6.5 FLOOR FINISHES TO PRINCIPAL ROOMS

Schedule of Changes
2022 Schedule of Changes for 42 Bedford Square - Revision 0

Second Floor Study

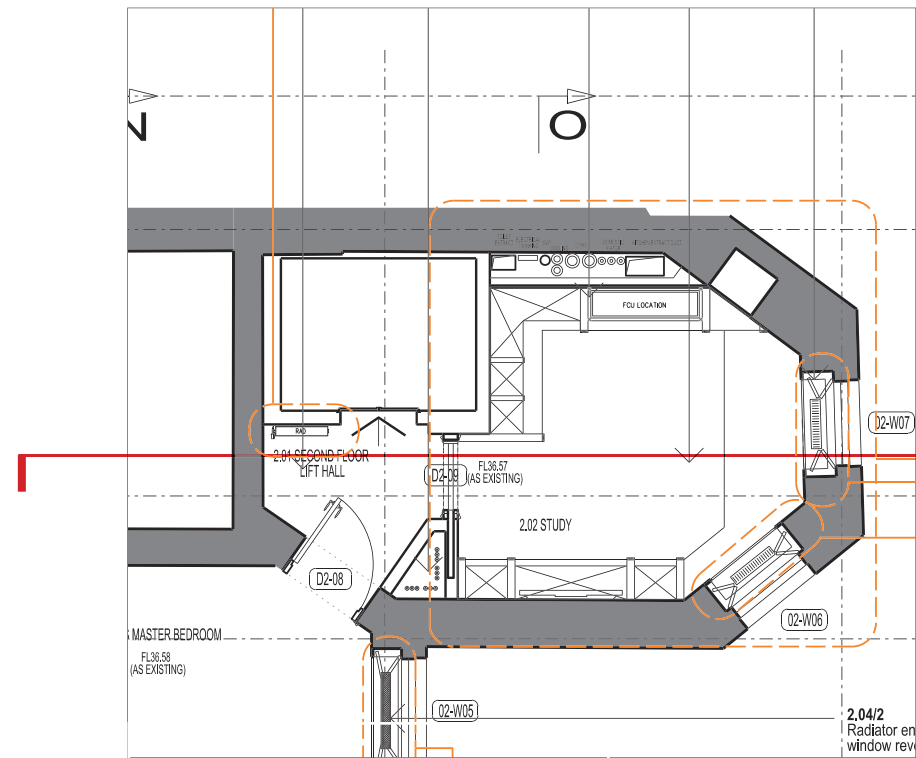
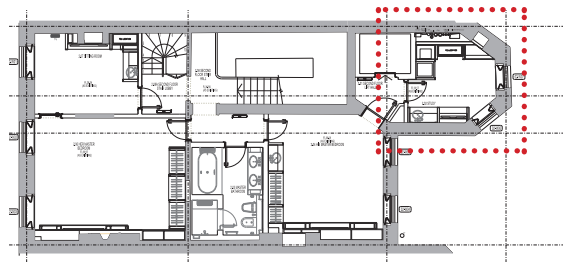
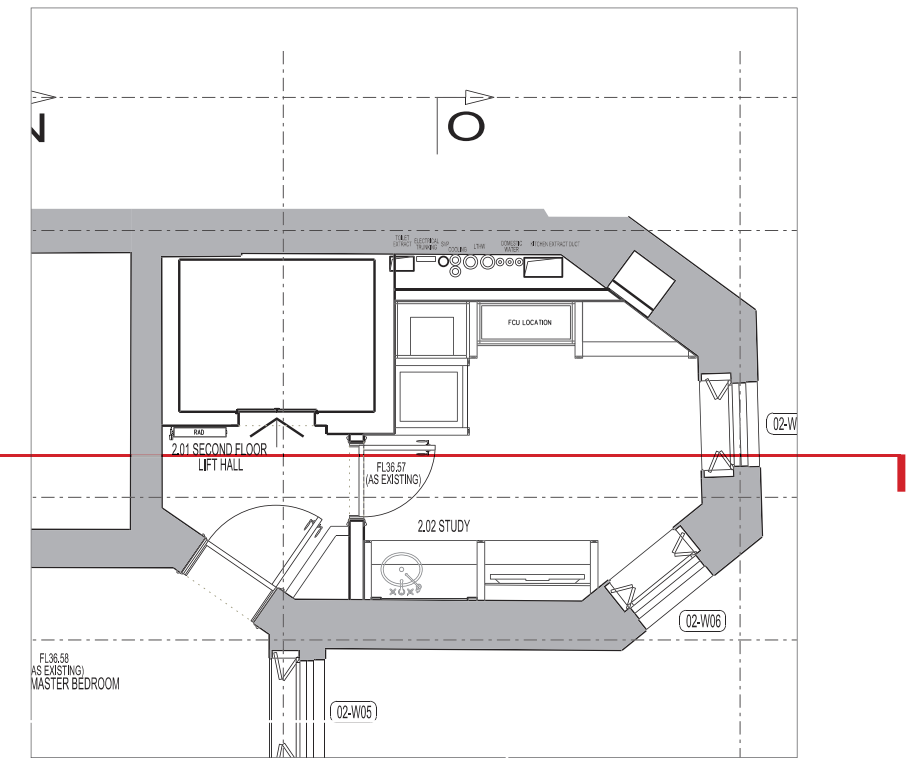
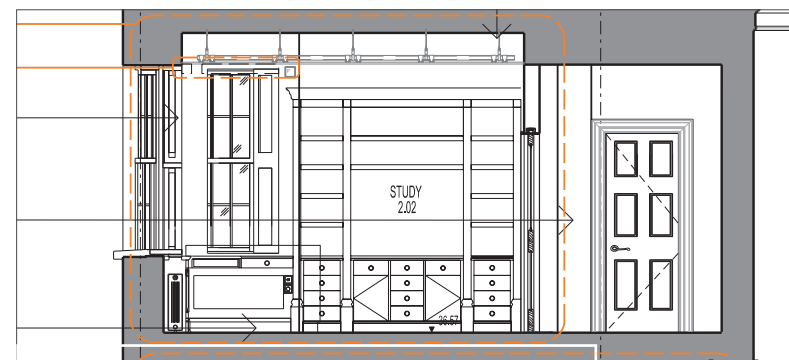
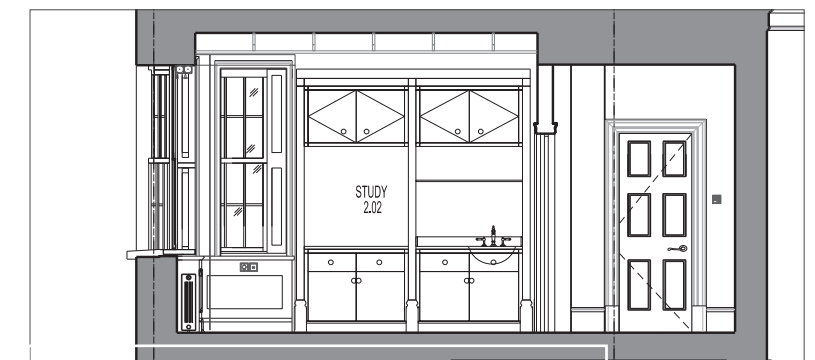
The design of the proposed fitted units has been revised. The desk has been omitted and a tea station is included.

Second Floor Bedroom

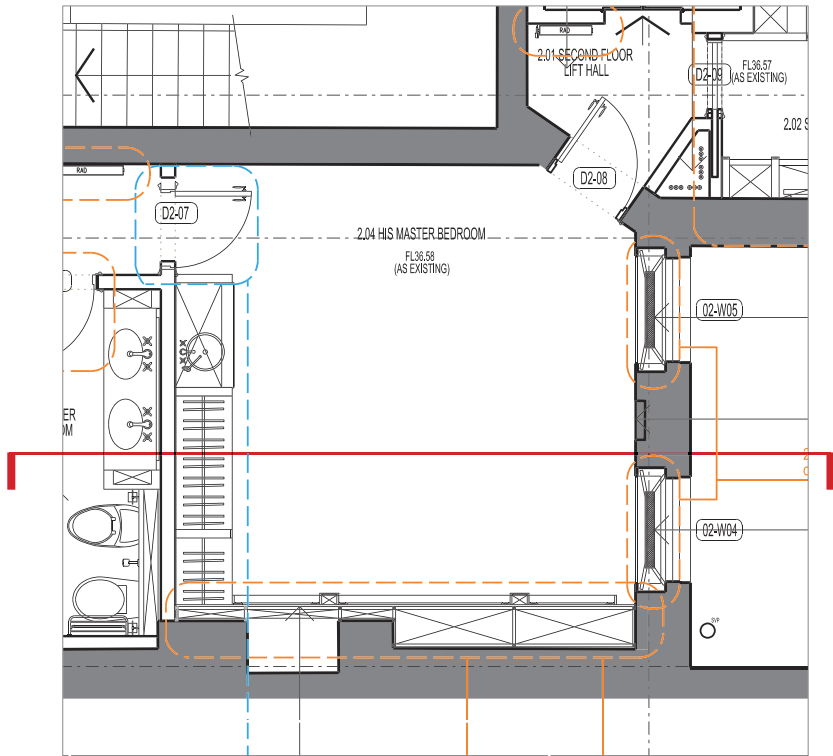
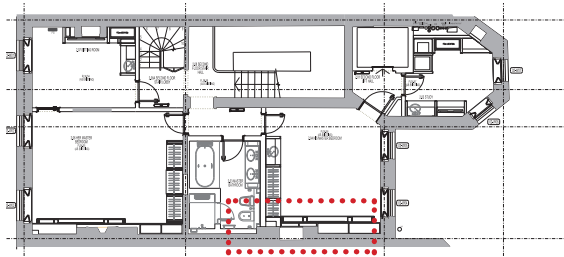
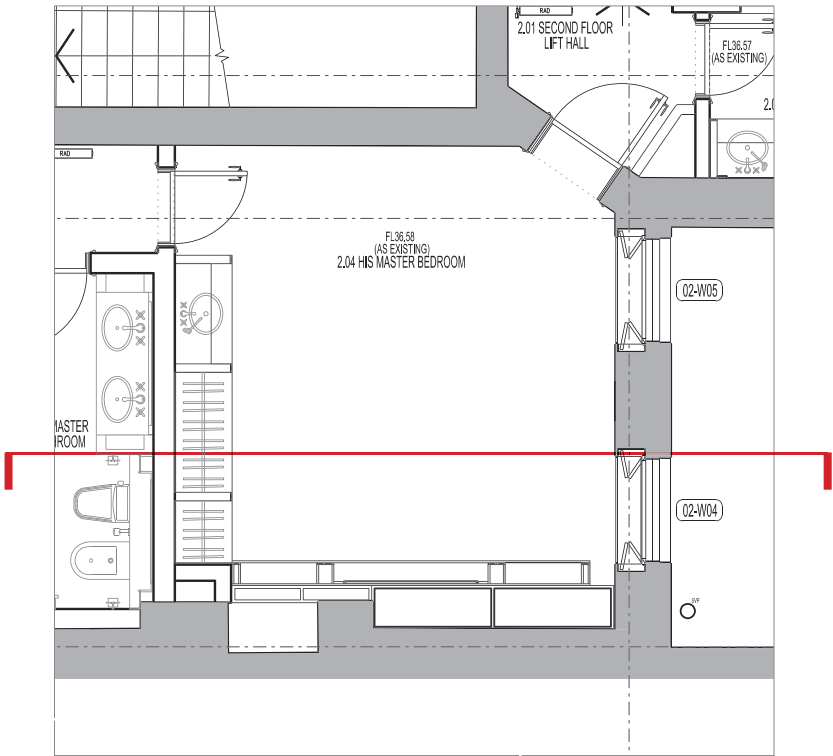
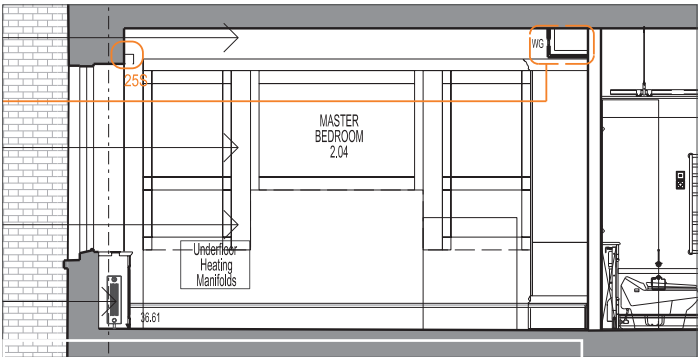
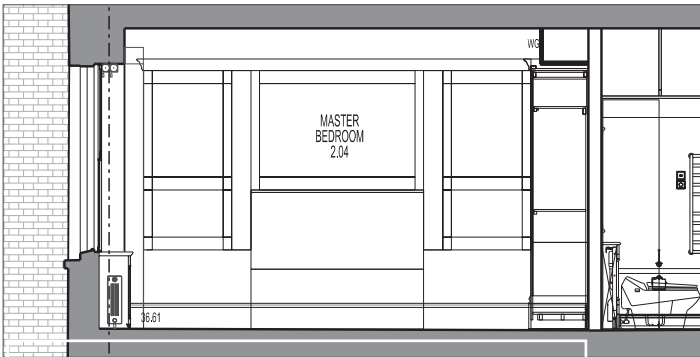
A minor increase to the projection of the fitted bed-head unit is proposed in order to accommodate building services including plumbing.

Third Floor Bedrooms

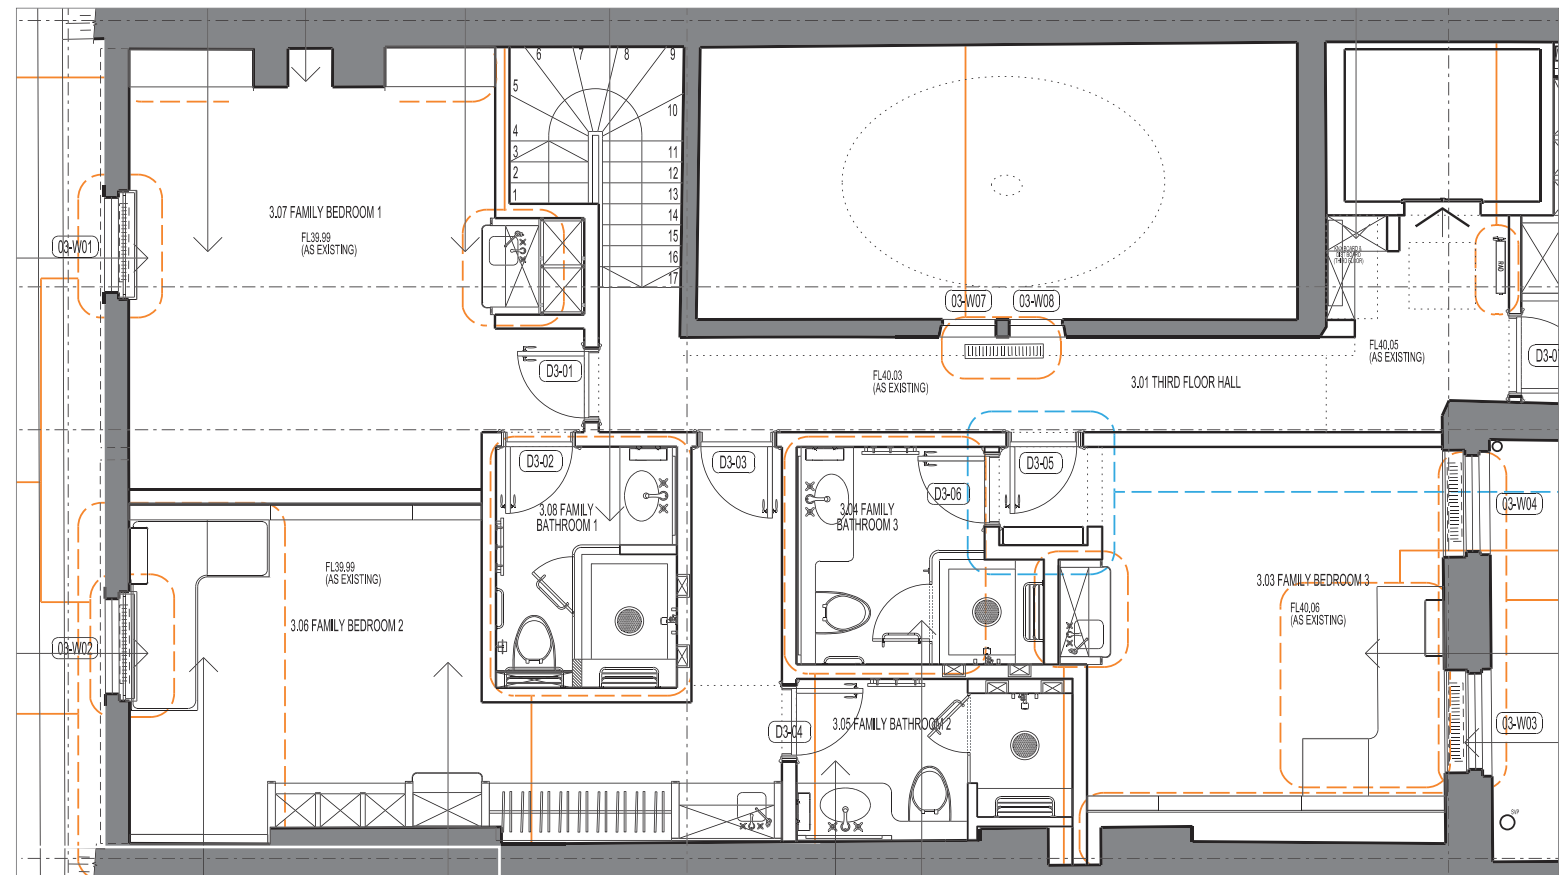
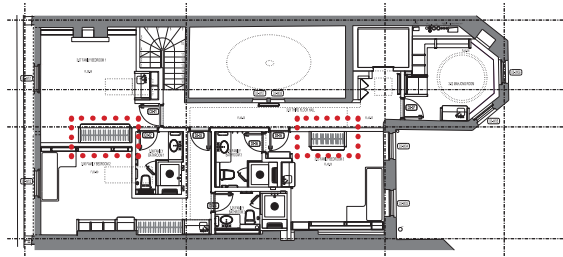
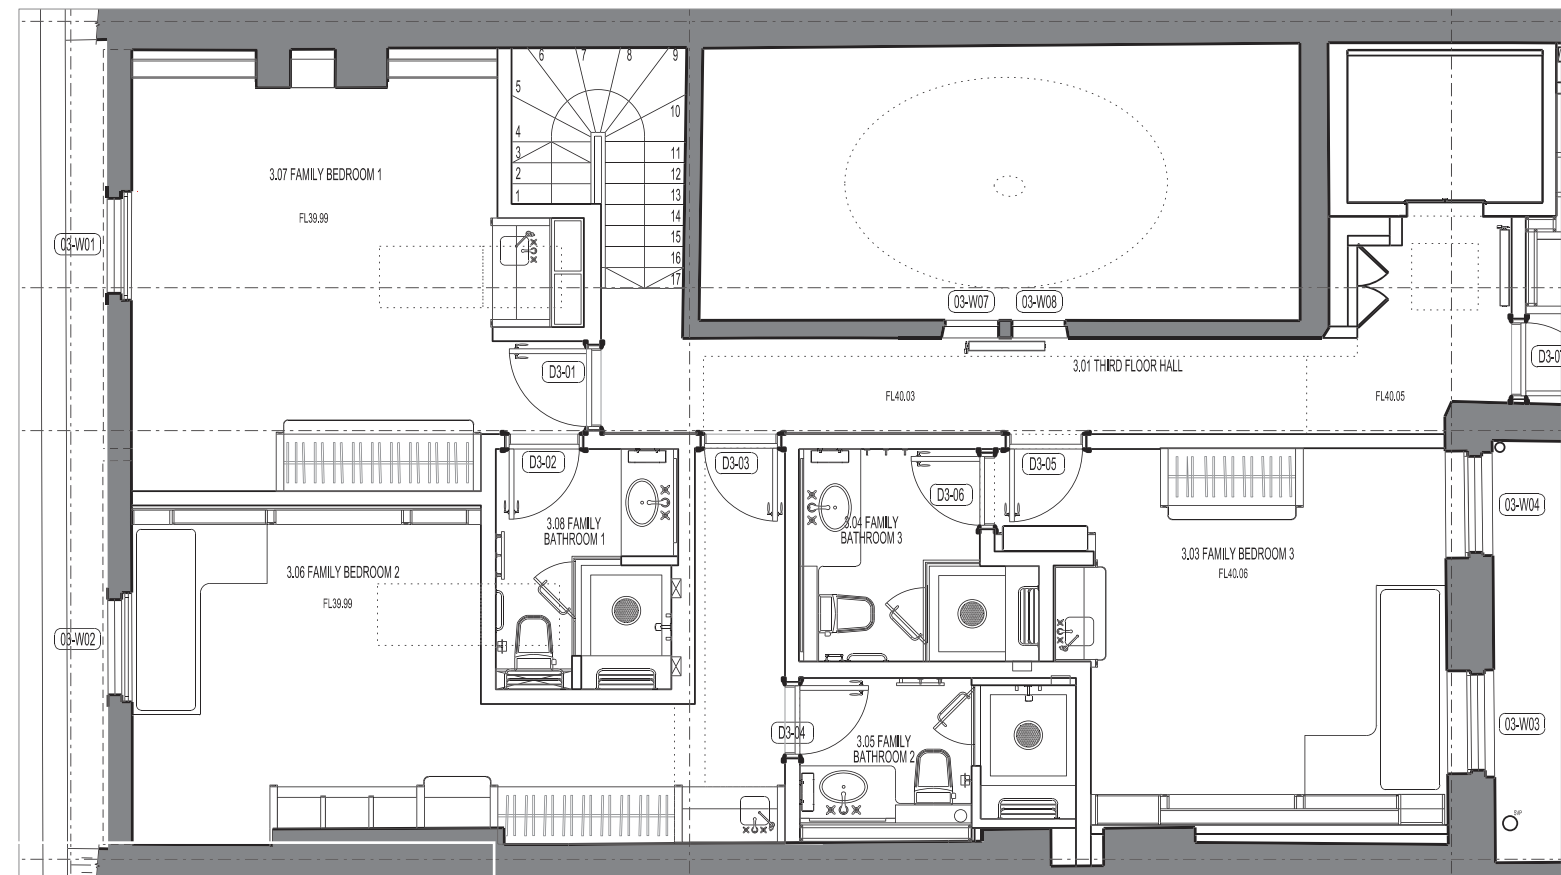
Fitted wardrobes are incorporated to Bedrooms 1 and 3 for consistency with other bedrooms throughout the house.

GROUND FLOOR CEILING PLAN - PROPOSED

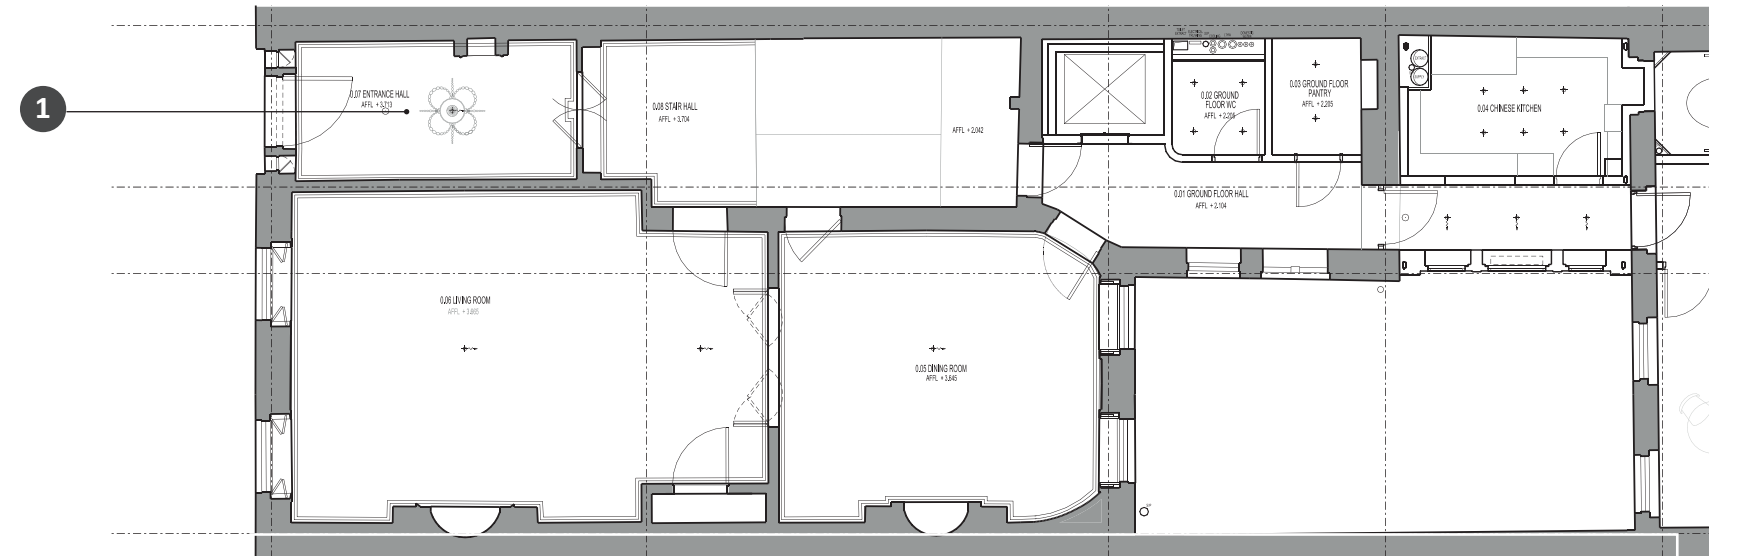
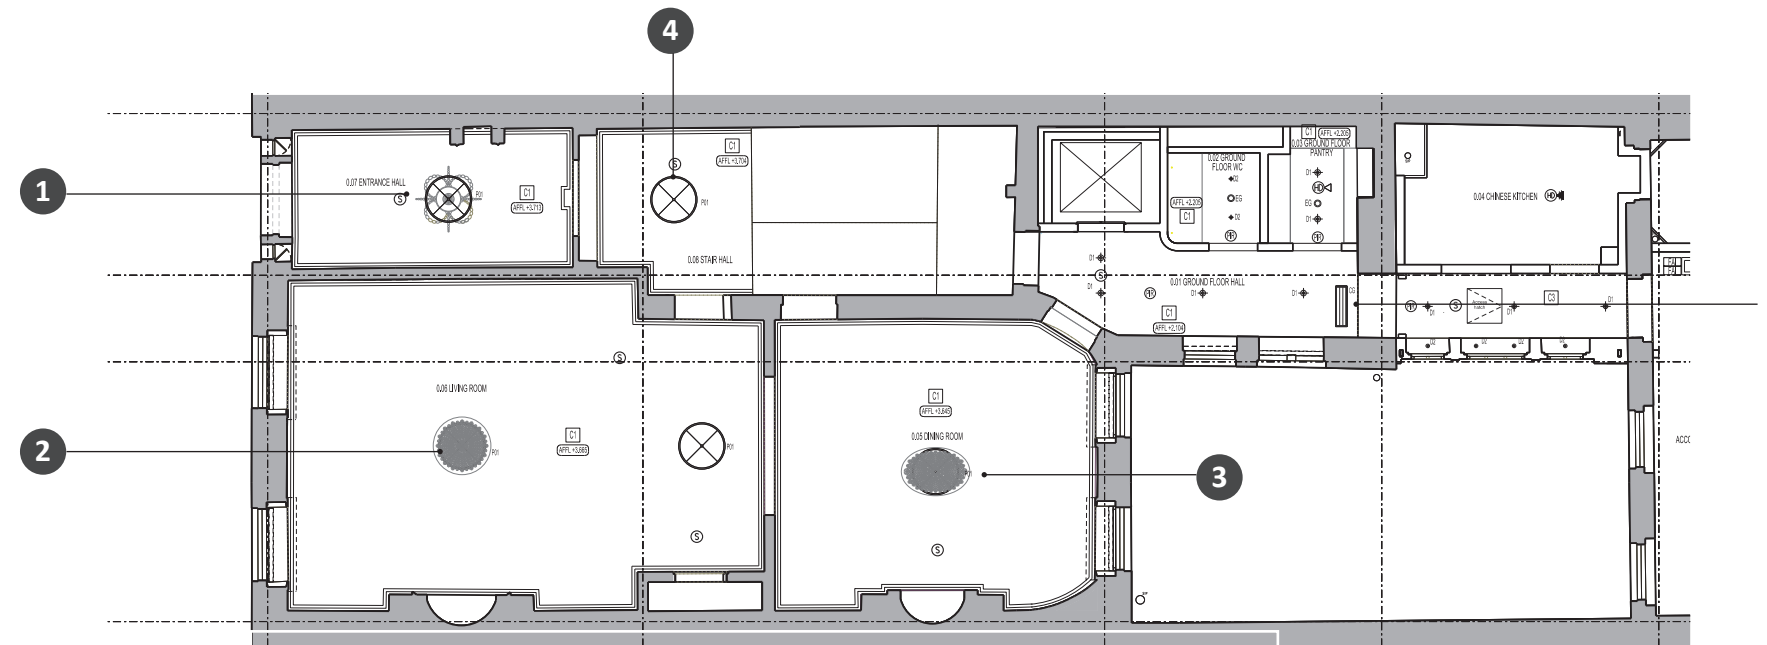
Two Ceiling roses are proposed to Ground Floor principal rooms. The existing ceilings are assumed original lath and plaster. There are no existing decorative plaster-works or roses remaining and plain ceilings are consented.

The ceiling roses proposed have been selected to emulate existing leaf motif roses to the First Floor and are proportionate in size. No cutting out of existing plaster work is proposed

FIRST FLOOR CEILING PLAN - PROPOSED

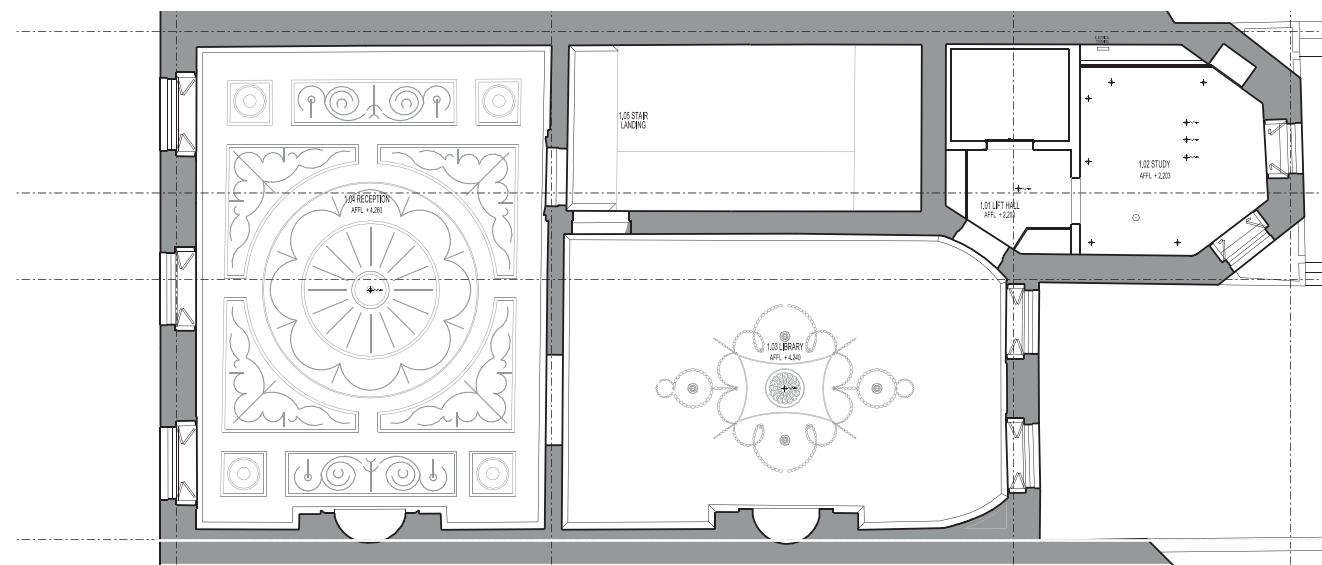
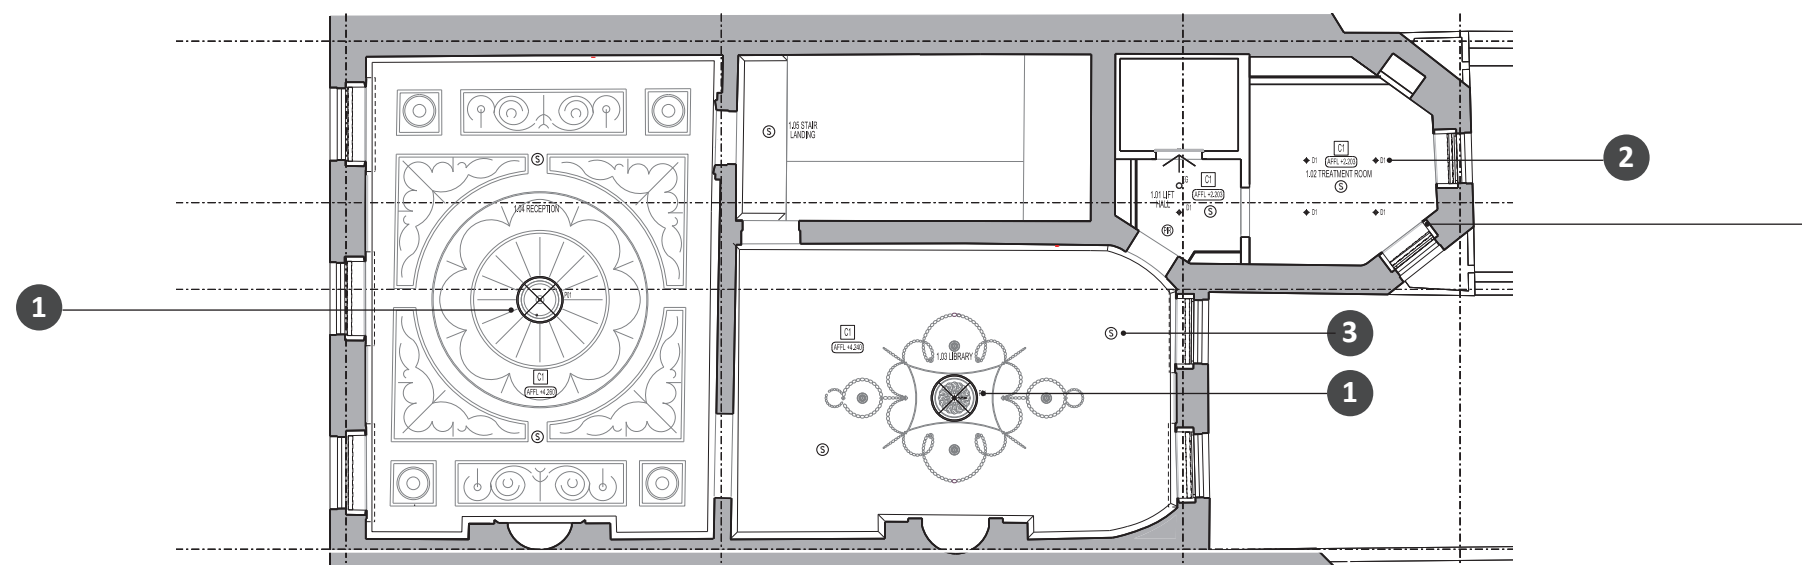
Pendant light fittings are proposed to central ceiling roses to the principal rooms.

A aspirator smoke detection system has been installed throughout the main house during the previous works contract. This system requires a very small opening within the ceiling in order to take continuous air samples. The system removes the requirement for larger surface mounted smoke detectors that would otherwise be required in order to meet fire safety requirements. Typically openings are circa 10-15mm in diameter and are visually unobtrusive, appearing as a small hole to the ceiling. The aspirator positions have been reviewed on site with the Conservation Officer on 16th March 2022 and were acceptable in principle.
